**Project: IEEE P802.15 Working Group for Wireless Personal Area Networks
(WPANs)**

Submission Title: comment resolution assignment

Abstract: proposes comment resolutions and text for a set of CIDs

Figure 23: Two Part Preamble

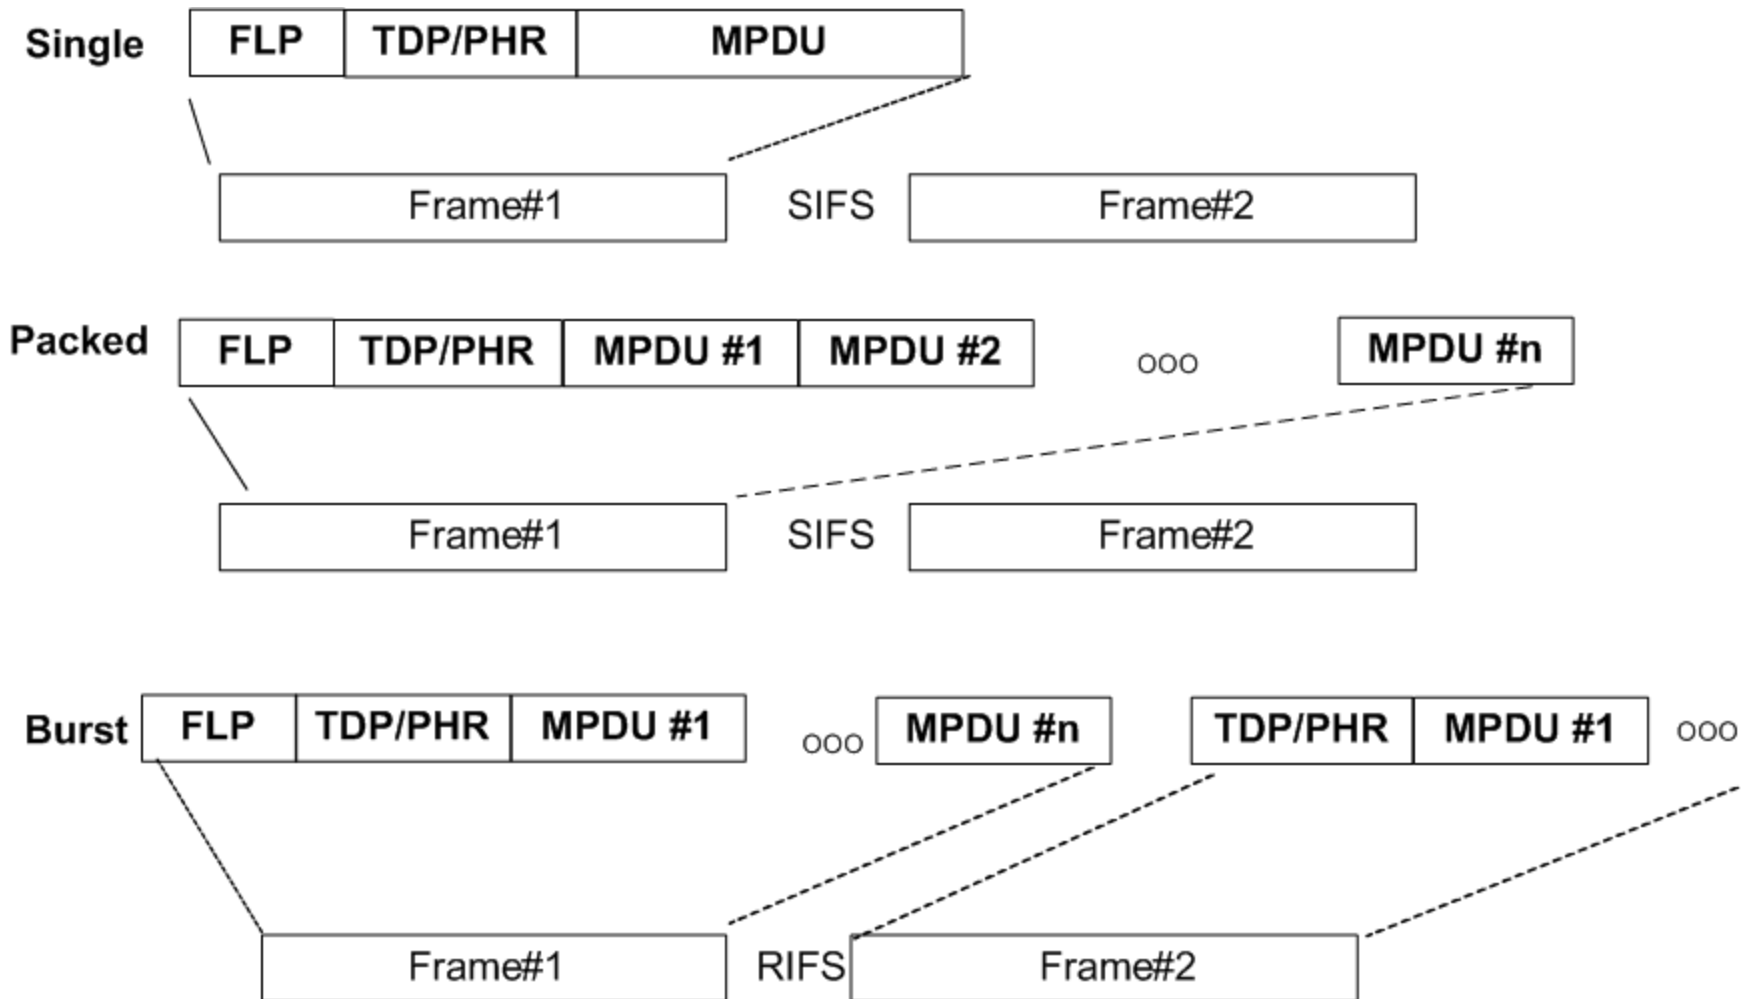
- In Figure 20, in Burst mode, there are two MAC PDU #n. These should be fixed.
- Figure 20 - Burst Mode - shows the same MAC PDU being transmitted twice, in both Frame #1 and #2. This figure does not align with the text
- (SY) In Burst mode, both packets are shown with the label "MAC PDU #n". I believe that the labels should be different

- Redraw the figure with correct PDU numbers.
- replace first MAC PDU #n with MAC PDU #1 and second MAC PDU #n with MAC PDU #2

Instruction to editor: Update Figure 23

Update Page 39, line 40 as follows:

- The standard defines one fast locking pattern (FLP) followed by choice of 4 topology dependent preamble (TDP) repetitions for the purposes of distinguishing different PHY topologies.

Update Page 39, line 46 as follows:

- After the fast locking pattern, 4 repetitions of one of four TDPs are sent.
